Your ref: SSI-48492458 Our ref: 12582669

16 February 2023

Waratah Super Battery - Response to Additional Information Request

Revised project layout figure

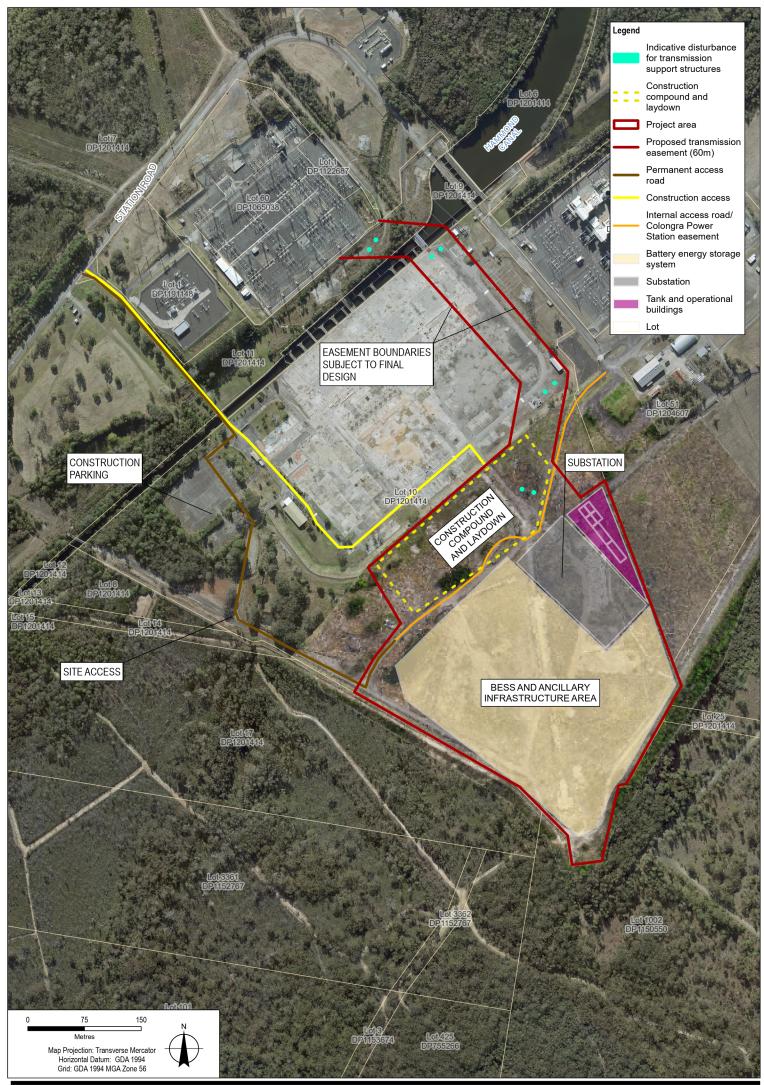
5. Provide a revised layout figure

Please refer to Attachment 2.
